Design and Access Statement

Extension to existing 6 units
and creation of 3 additional units at
106-116 Westfield Road, Caversham
Reading RG4 8HJ

May 2019
Avalon Construction and Design

Figure 8 Headroom at first and second floor [Ref. Drawing ACD 0518 1104 Floor to ceiling height First and Second].

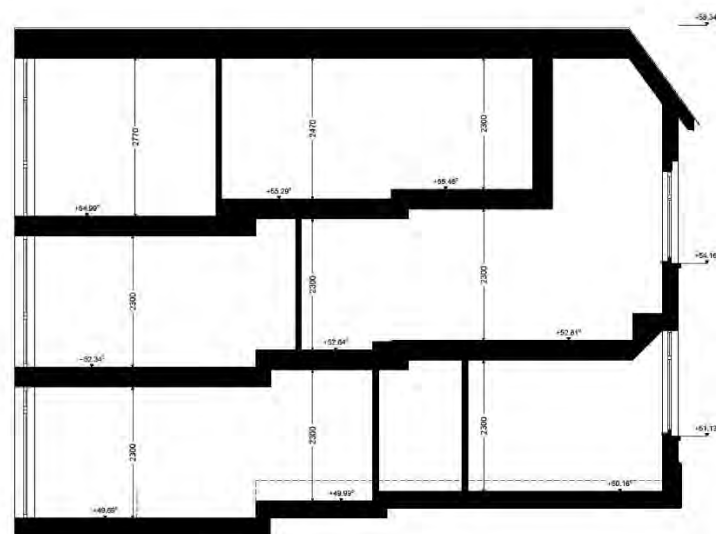
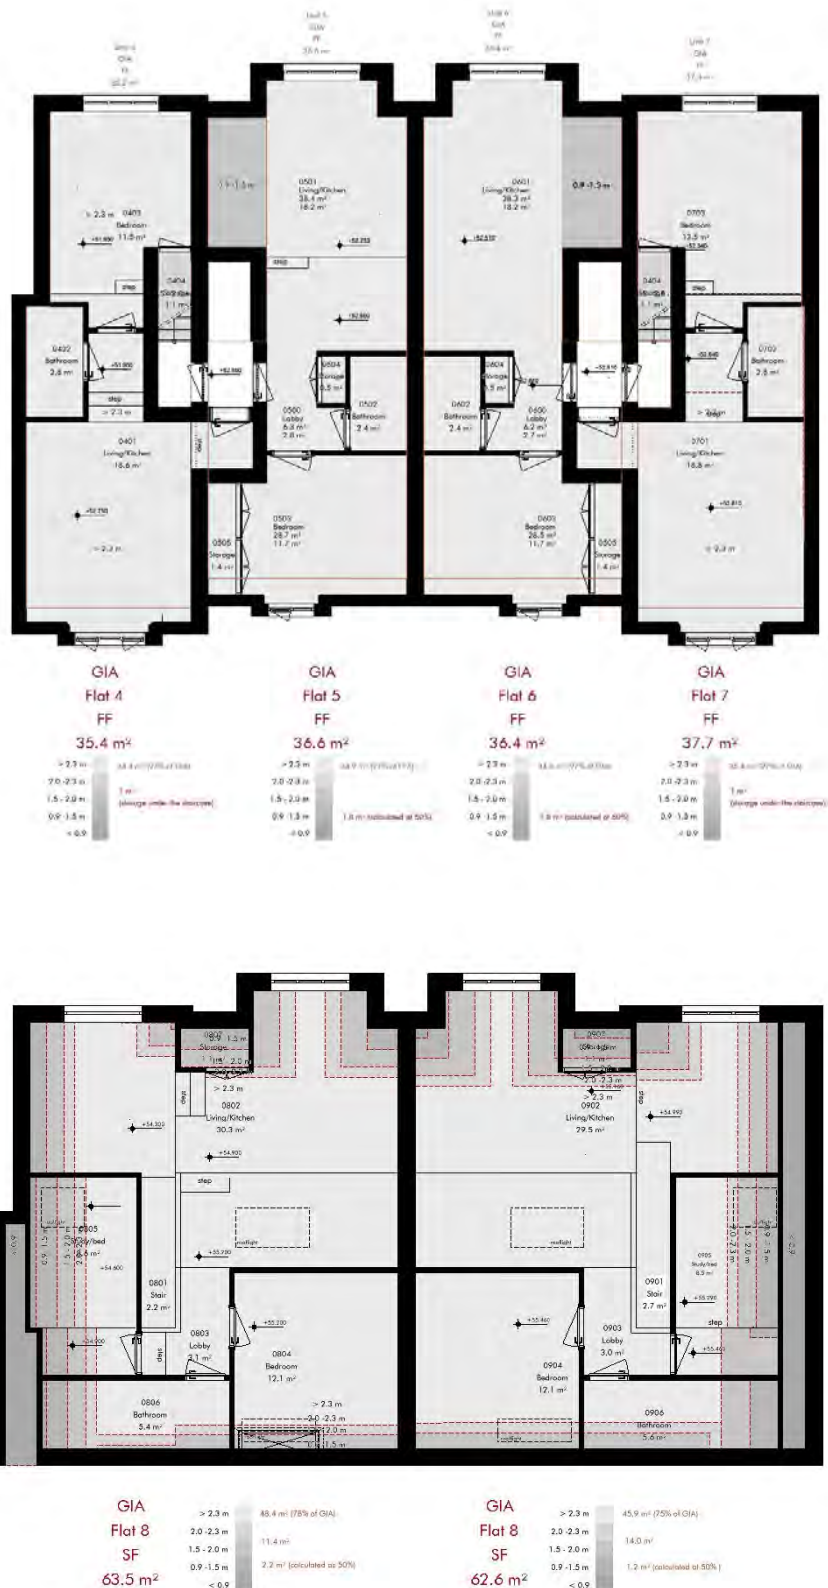
[...] in any future application , all floorspaces be clearly identified, and measurements and methodology be provided for the calculation of habitable floor space, including any spaces with <1.5 m head height, and that a full analysis of the National Housing Standard be included (i.e. a table showing compliance with requirements) to aid assessment. This should include identification of head heights of 2.3m for 75% of each unit. Sectional plans would assist.

The footprint for the units has been calculated excluding all the floorspace with headroom below 0.9, headroom between 0.9 and 1.5 m has been calculated at 50% and anything above 1.5 m at 100%.

The single bedrooms to units 8 and 9 have a footprint of 8.6 m²: 6.9 m² with headroom above 1.5 m (counted at 100%) and 1.4 m² with headroom between 0.9 and 1.5 m for storage (counted at 50%) for a total of 7.6 m² (see also Figure 6 showing headroom second floor).

Figure 8 Diagram of the proposed outdoor space.

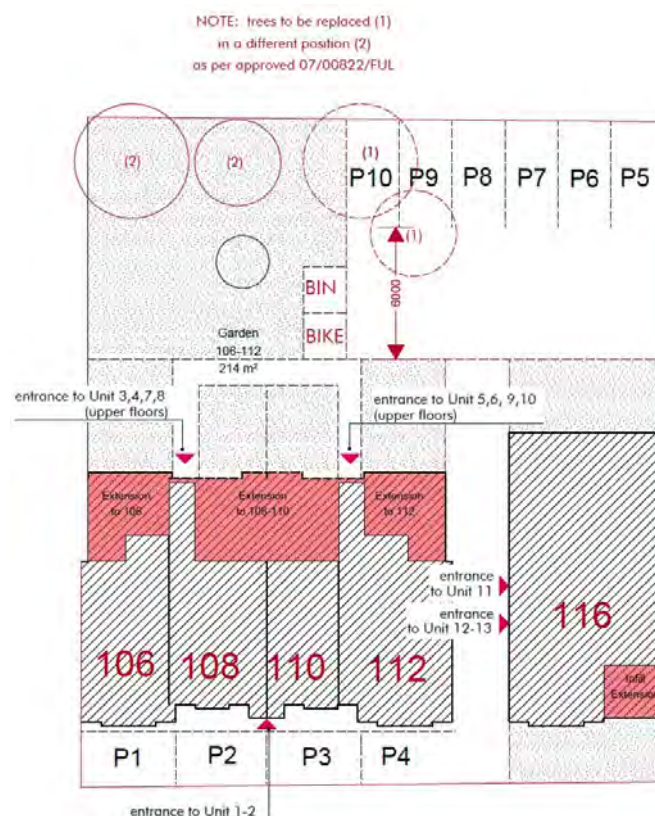
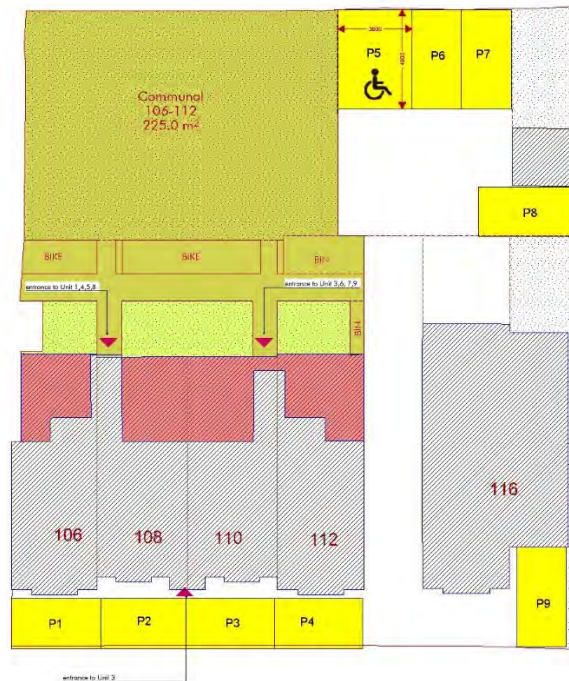
The Case Officer expressed concerns as the increased number of parking spaces to the rear (Pre-Application scheme) would result into a loss of amenity space. Additional information and clarifications were required in regard to bin and bike storage provision (size and location) and lack of parking space for disabled people.

The new scheme address all those concerns as showed in the plan below:

The new proposal doesn't increase the number of parking spaces (see above paragraph 3.3 "Transport/services: parking spaces).

Figure 13 Daylight Factor analysis at Ground Floor

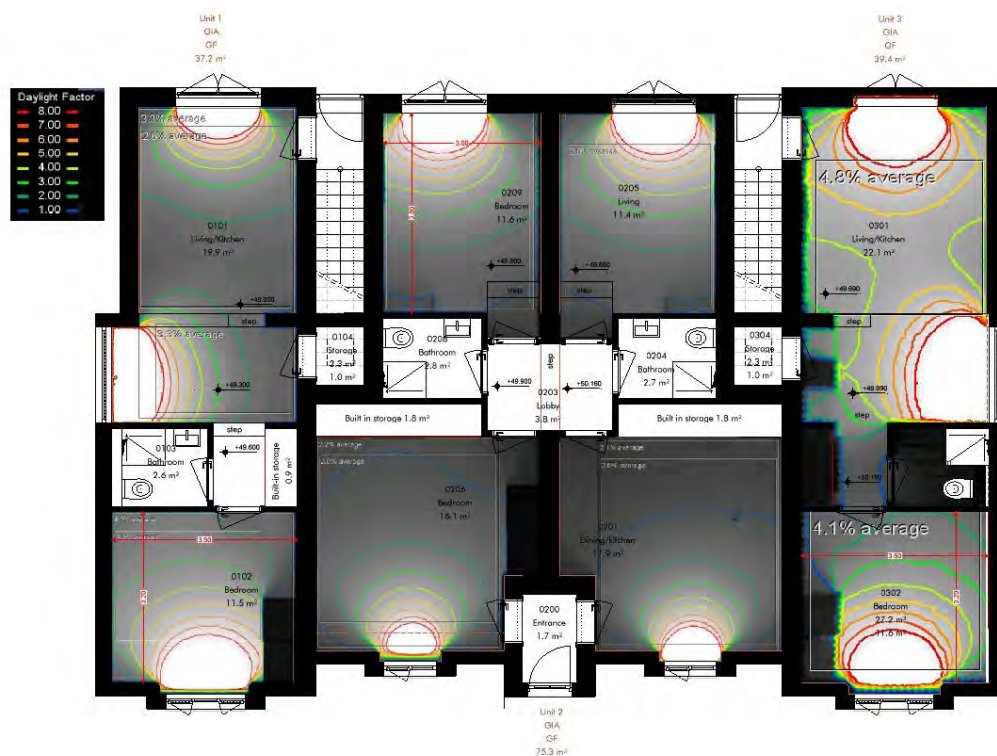
The Pre-Application report made required a Daylight/Sunlight report to be provided as concerns were expressed about the level of natural light in the proposed scheme.

One of the alterations suggested by that analysis has been the introduction of two large windows to the kitchen at ground floor, flats 1 and 3. Those windows, which would require obscured glass to avoid overlooking issues, although opening towards partially enclosed space, help in bringing natural light to the kitchen area (see diagram below).

Figure 14

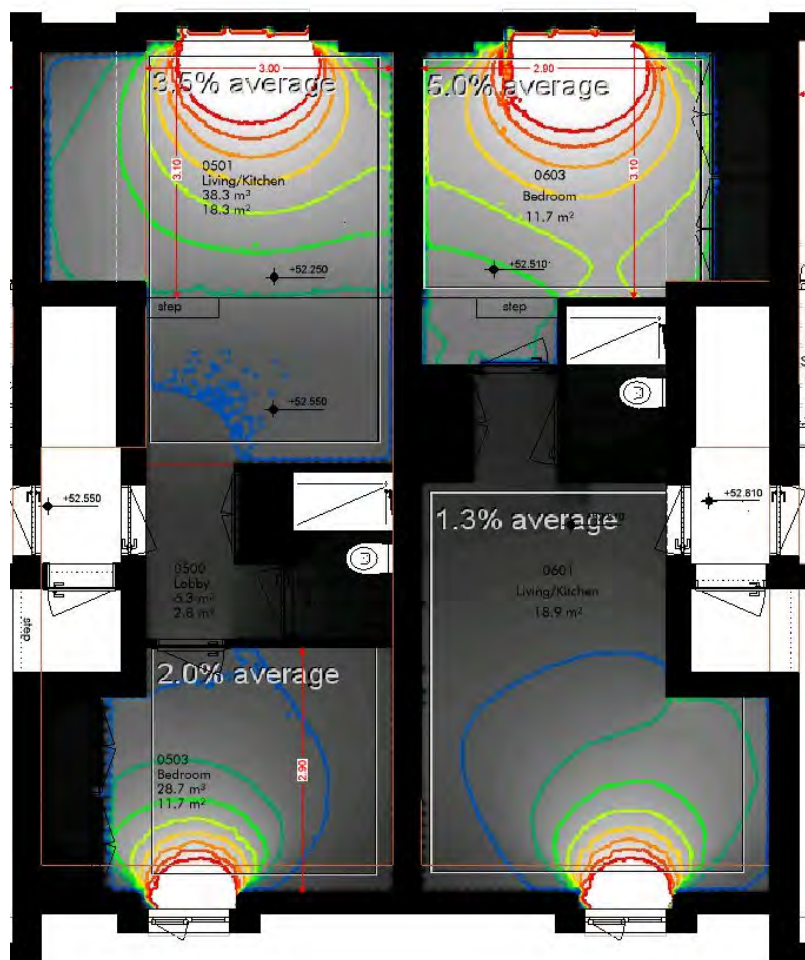
During the design process, the Daylight/Sunlight analysis led to change the layout of the central unit at first floor (Flat 5 and 6).

Original Layout (on the right): the living room is poorly illuminated by the existing small window to Westfield Road and the bedroom to the rear has level well above the standard;

New Layout (on the left): The small existing window to Westfield Road is sufficient to provide minimum level of natural light (2% Average Daylight Factor) and the living/kitchen to the rear is well illuminated by the new large window.

DAS 4.2.2

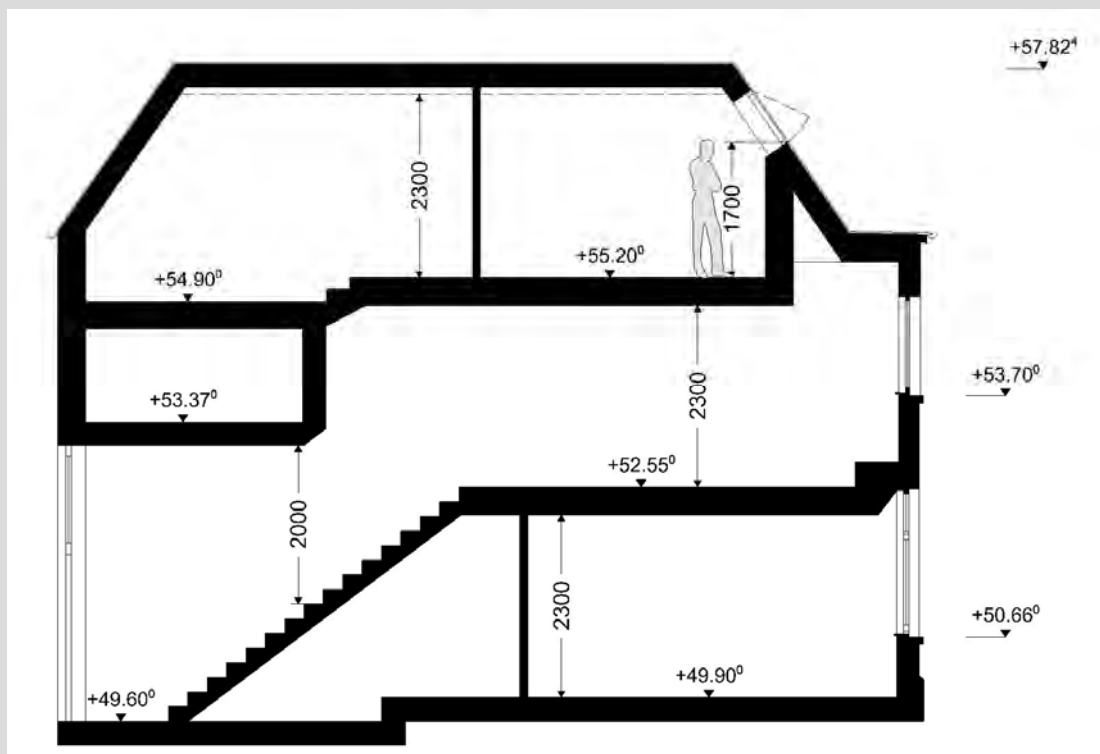
The proposal currently includes the provision of two front facing rooflights sitting on the plane of the existing roof and two South facing (toward 104 Westfield Road). The proposal incorporates two South facing windows which would result in the potential for overlooking and/or loss of privacy to the

adjoining property. As such, it is not considered appropriate that windows be located where there would be a perceived or real loss of privacy due to

overlooking.

There are no new South facing window to the existing façade and there are two rooflights sitting on the plane of the existing roof. However, these rooflight have been set with the lower edge at 1.70 meters from the Finish Floor Level (see section below) to avoid overlooking and/or loss of privacy to the adjoining properties.

This solution has been preferred to obscured glass since it maximizes daylight and sunlight and it ensures the sight of the sky that is beneficial for the quality of the space.

The window located at ground floor level and the rooflight towards 104 Westfield Road will be obscured glass.
